Job No. 07489-3

Subject: Grading Plan Review and Update to Geotechnical Investigation
 Proposed Industrial Development - Sycamore V
 Lance and Sierra Drives
 Riverside, California

As requested, we have reviewed the 40-scale Precise Grading Plan prepared by GFB - Friedrich & Associates, Incorporated, dated June 2008, as it pertains to the geologic/geotechnical aspects of the development (Sycamore V). This firm conducted a geotechnical investigation on the site (July 20, 2007). It is our understanding that the subject site is to be developed with an approximately 1.1-million square feet industrial structure and related infrastructure. It is anticipated that the site will be developed with one- to two-story structures of concrete tilt-up construction, utilizing conventional spread foundations for support.

ENCLOSURE
1

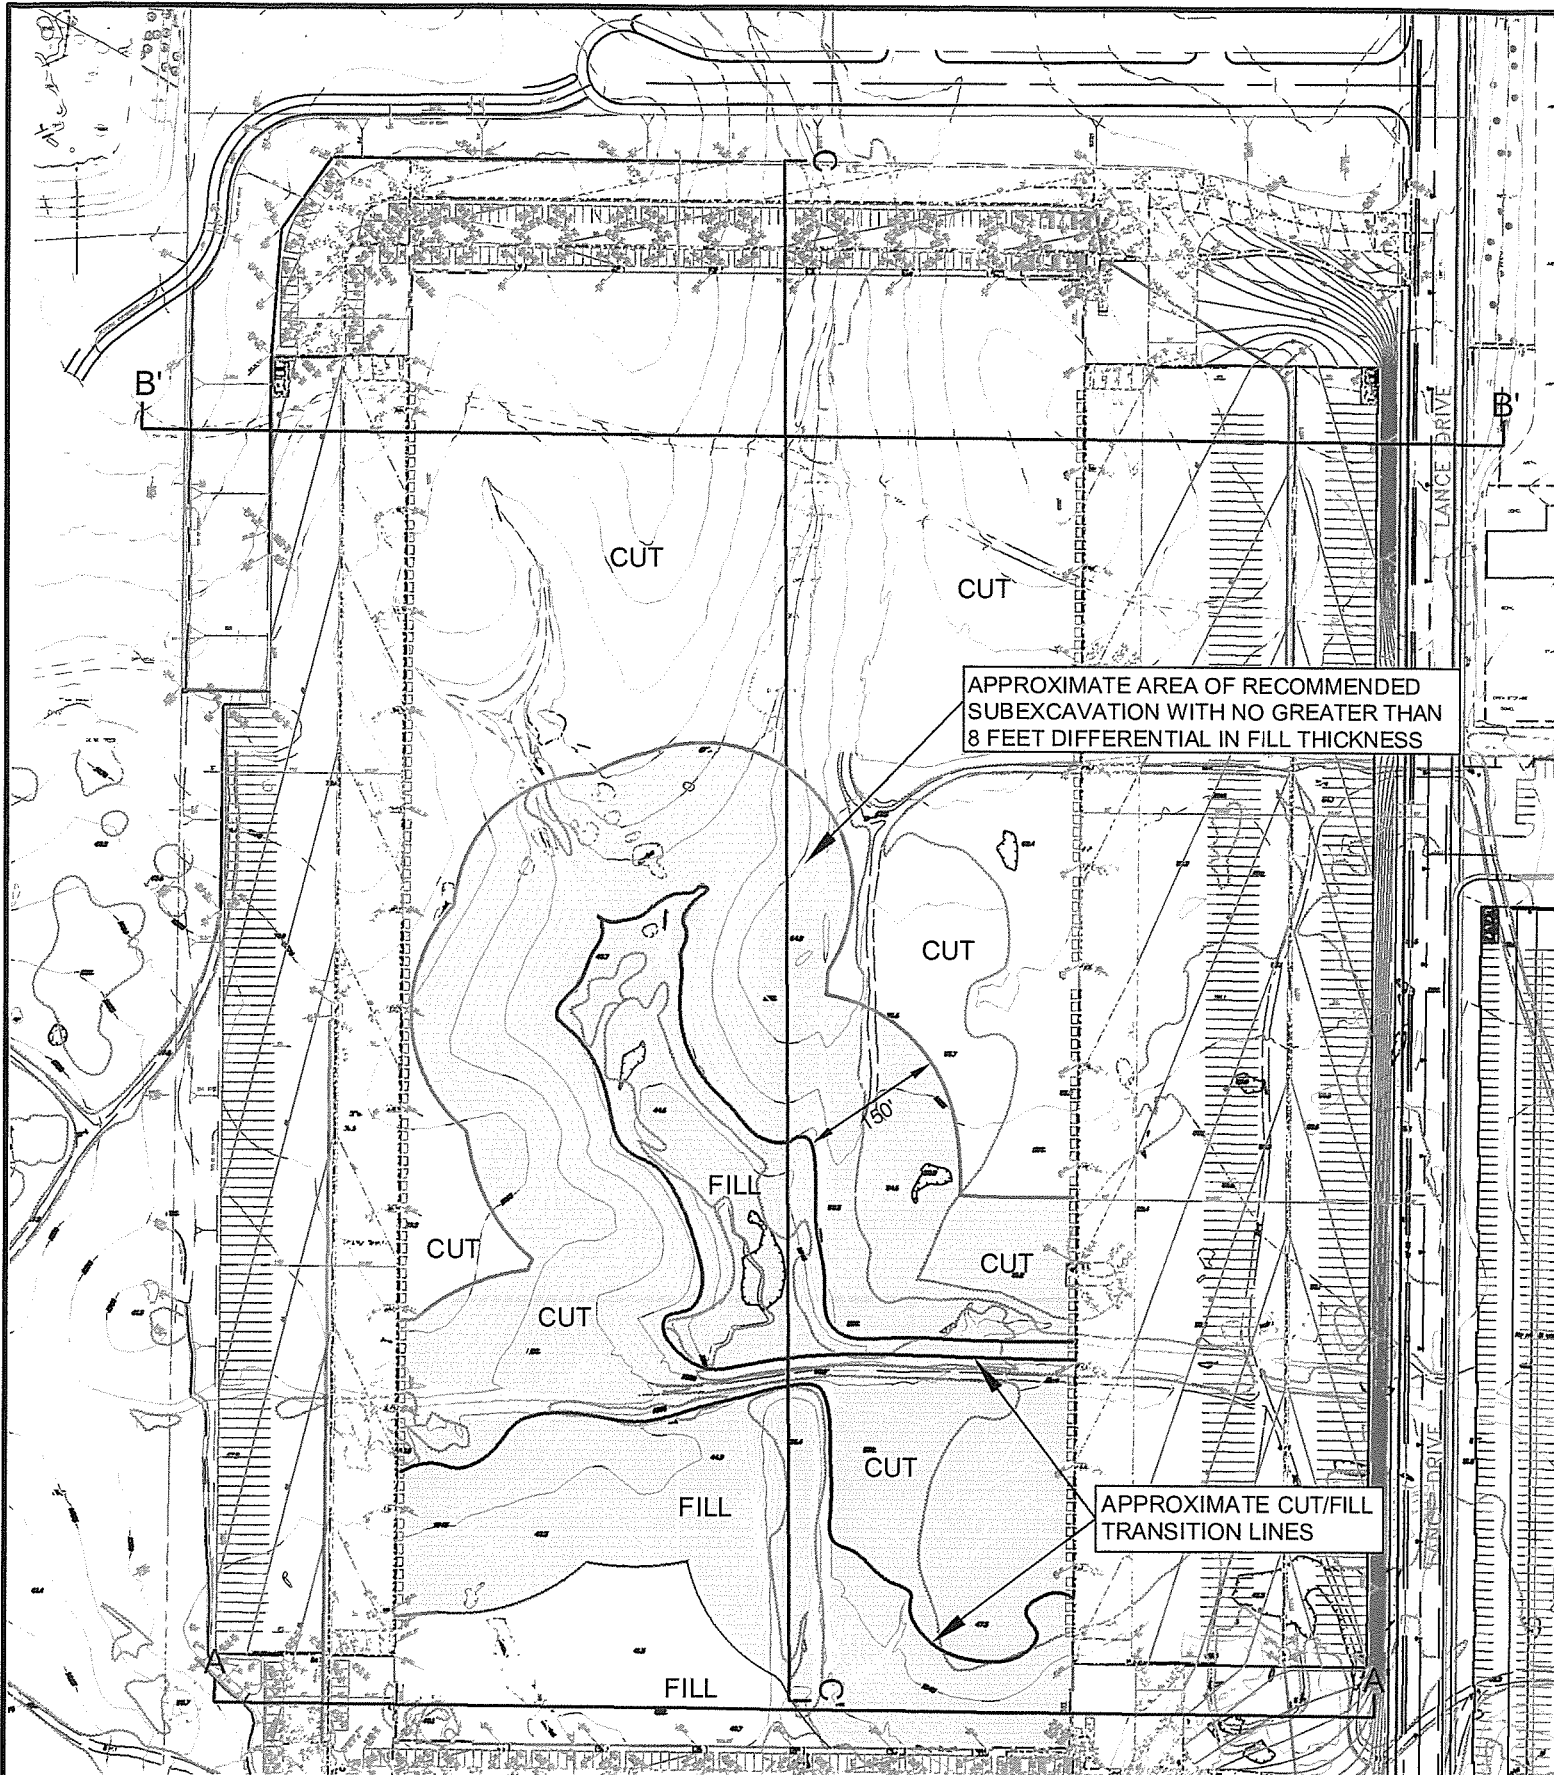
16 feet, when alluvial/colluvial removals are included. Cut-fill transition lines are present in the southern and central portions of the proposed building (Enclosure 1). In order to mitigate the potential for differential settlement across the cut/fill transition area, the pad area including areas underlain by bedrock, should be subexcavated to provide no greater than 8 feet difference in the fill mat thickness within 150 feet of the cut/fill transition line. The 150-foot distance from the transition line is also shown on Enclosure 1. The attached draft cross sections illustrate the cut/fill transition, areas of fill, bedrock cut areas, and potential fill depths beneath footings in rock areas. Our geotechnical investigation recommended a minimum fill thickness of 18 inches beneath all structure footings.
